Staff Report

To: Salt Lake City Planning Commission
From: Katia Pace, (385) 226-8499, katia.pace@slcgov.com
Date: January 13, 2021
Re: PLNPCM2020-00727, Windsor Court - Planned Development

A Planned Development, **PLNPCM2020-00727**, is needed to address a modification to the front yard setback and landscape buffers.

Street Frontage

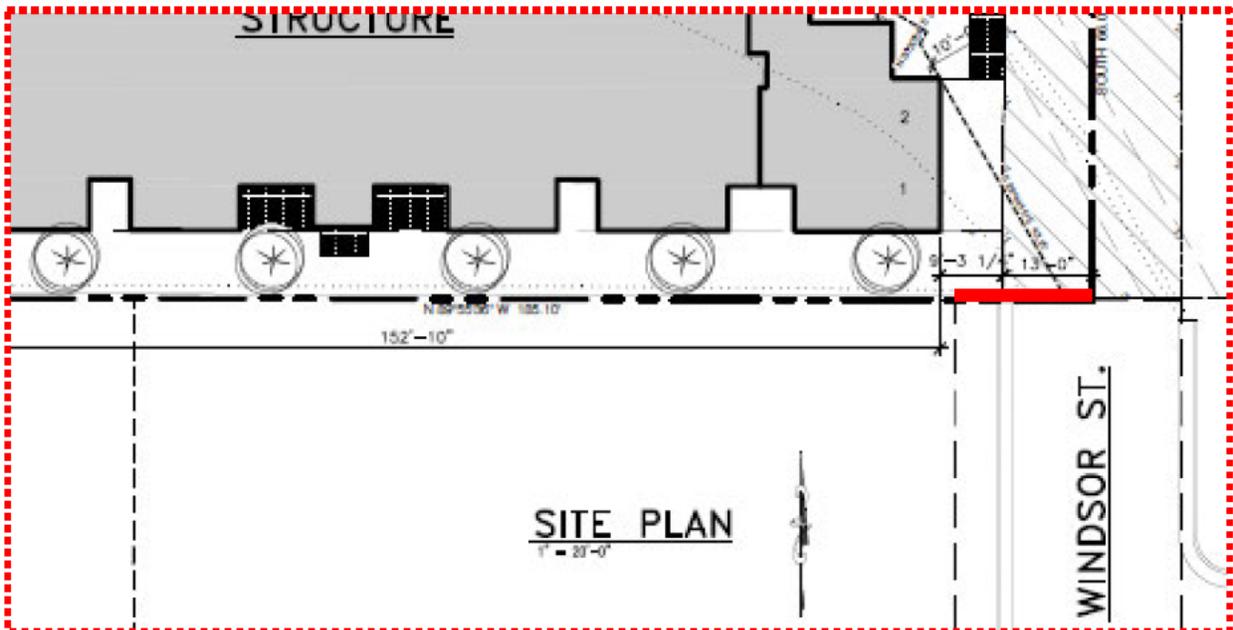
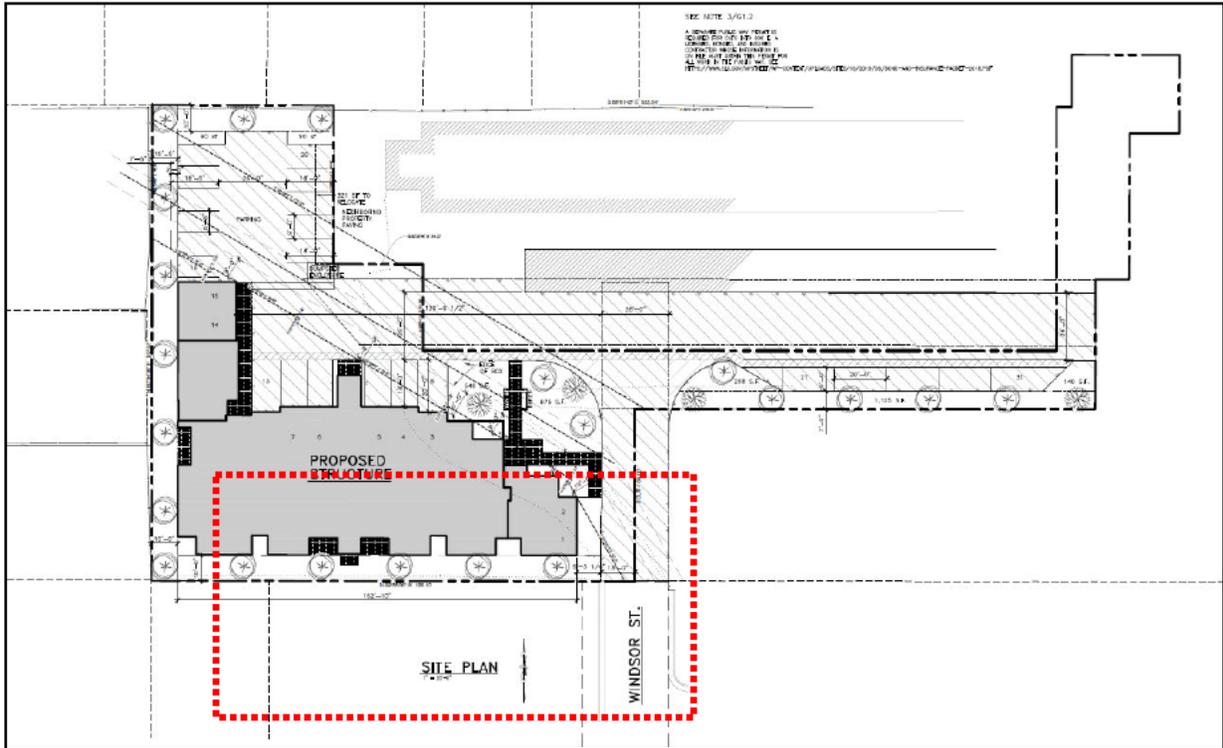
Preliminary review called this parcel as not having street frontage because the city and county's map show the portion of Windsor Street that gives access to this project as being part of the lots abutting the street. However, with closer examination it was determined that this portion of Windsor Street is in fact a public street.

According to the Salt Lake City Zoning Ordinance Section 21A.36.010.C, all lots in any zoning district must have frontage on a public street. And according to the definition of Street Frontage on Section 21A.62: “All of the property fronting on one side of the street between intersecting streets, or between a street and a waterway, a dead end street, or a political subdivision boundary, and having unrestricted vehicular and pedestrian access to the street” technically this property has street frontage because there is approximately 21 feet of the property that faces Windsor Street.

Parley's Creek Easement

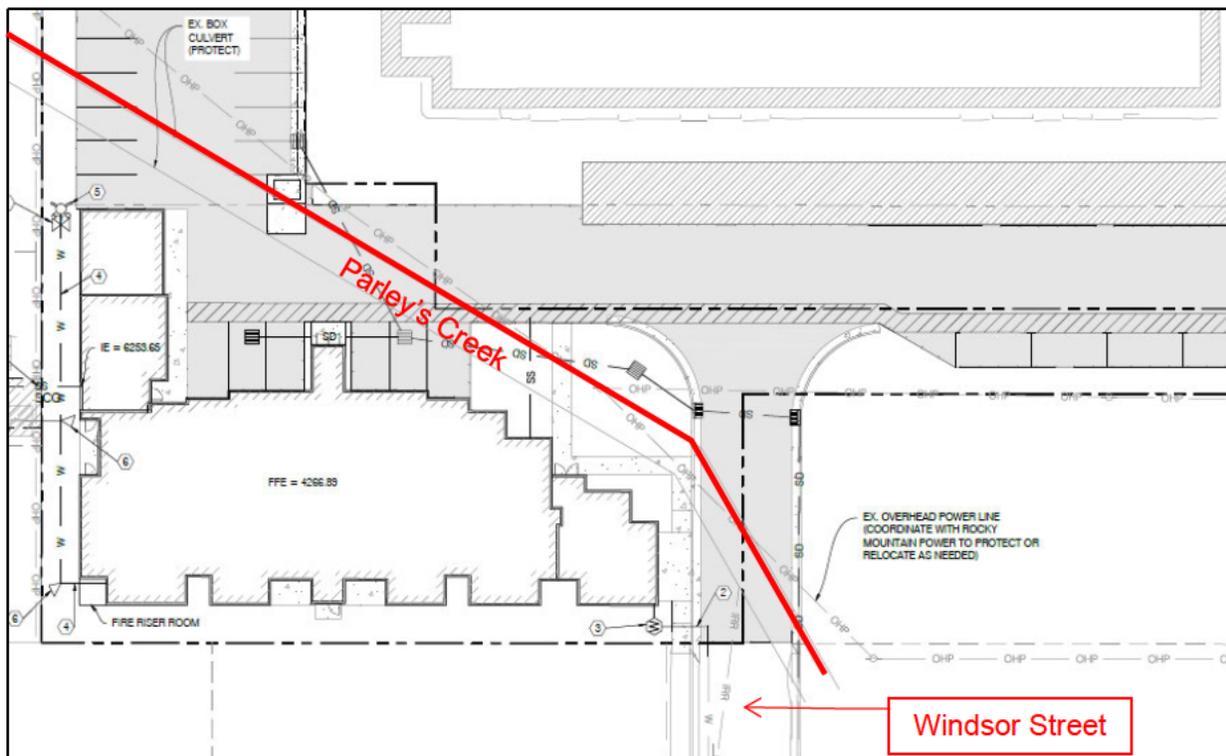
This lot has an irregular shape and Parley's Creek goes through the underground of this property; the building cannot be built in the easement. The proposed building is designed to maintain the required setbacks from the Parley's Creek Easement.

Traffic Impact

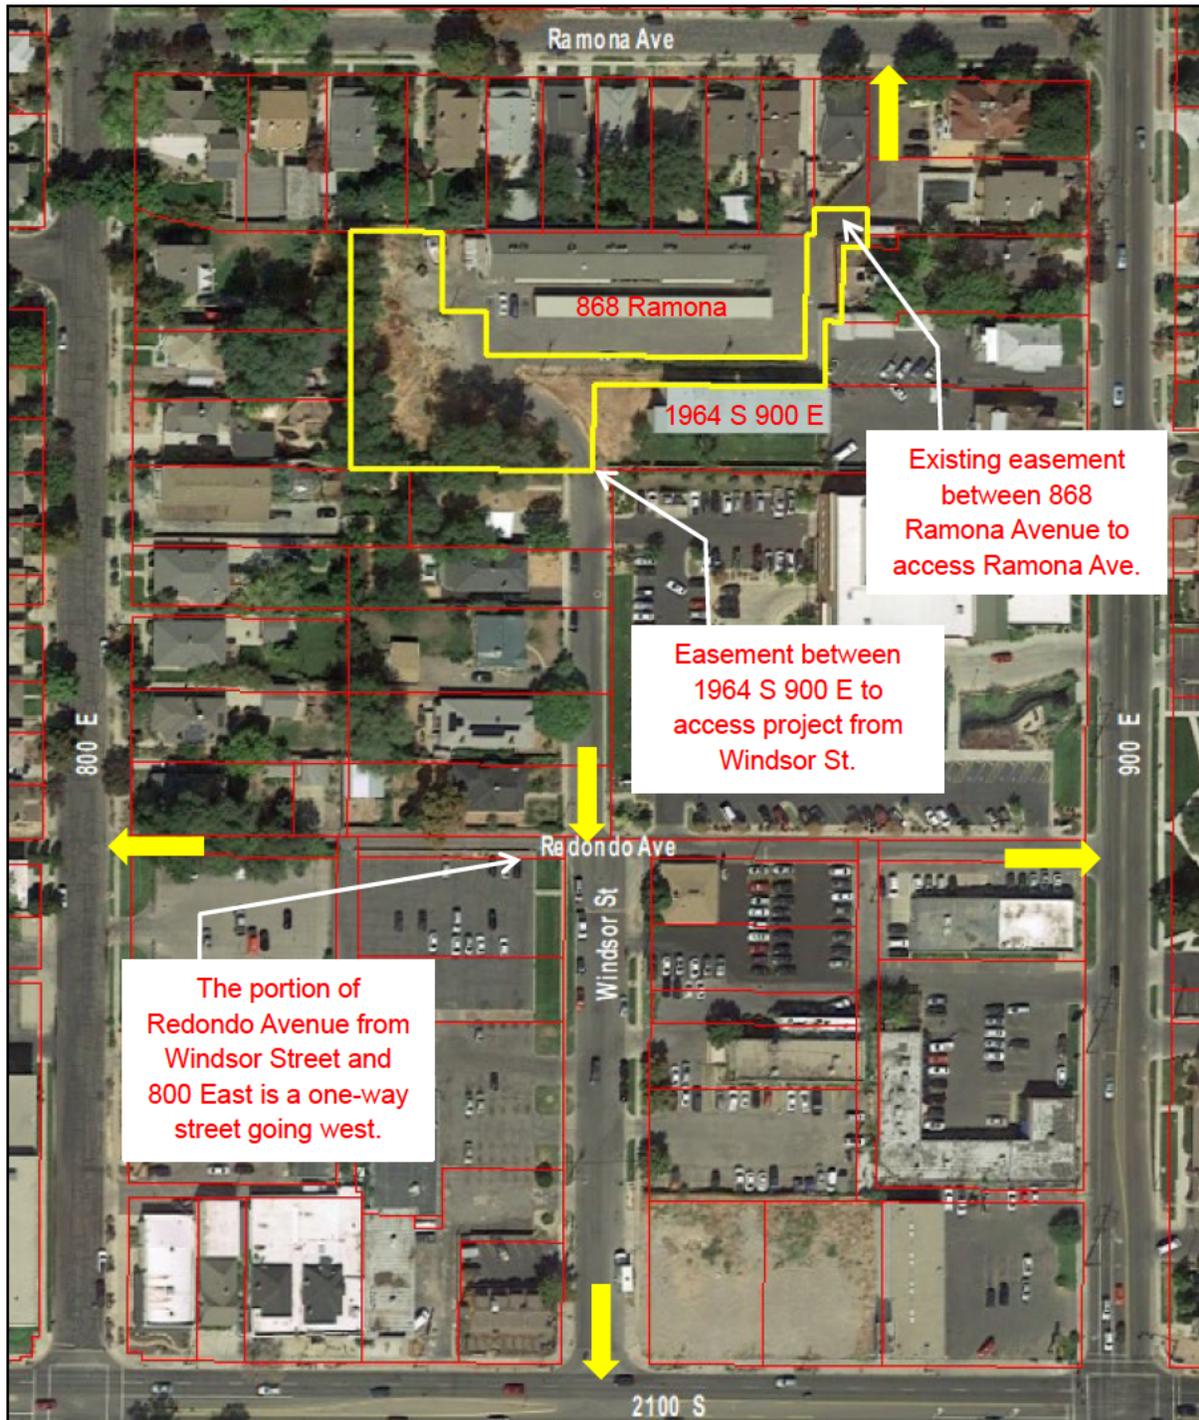
The main vehicular and pedestrian entrance to the project will be from Windsor Street where the driveway faces 13 feet of the street and the remainder of the driveway is an easement between the abutting property at 1964 South 900 East. Another easement exists between 868 Ramona Avenue for interior circulation. A potential secondary access will be to Ramona Avenue, there is an easement between this project and 1940 and 1932 E. 900 South that is used by the existing mid-block building at 868 Ramona Avenue to access Ramona Avenue.

From Windsor Street a vehicle, pedestrian or bicycle has the option to turn onto Redondo Avenue to access either 800 or 900 East (the portion of Redondo Avenue from Windsor Street and 800 East is a one-way going west), or continuing on Windsor Street and turning on 2100 South.
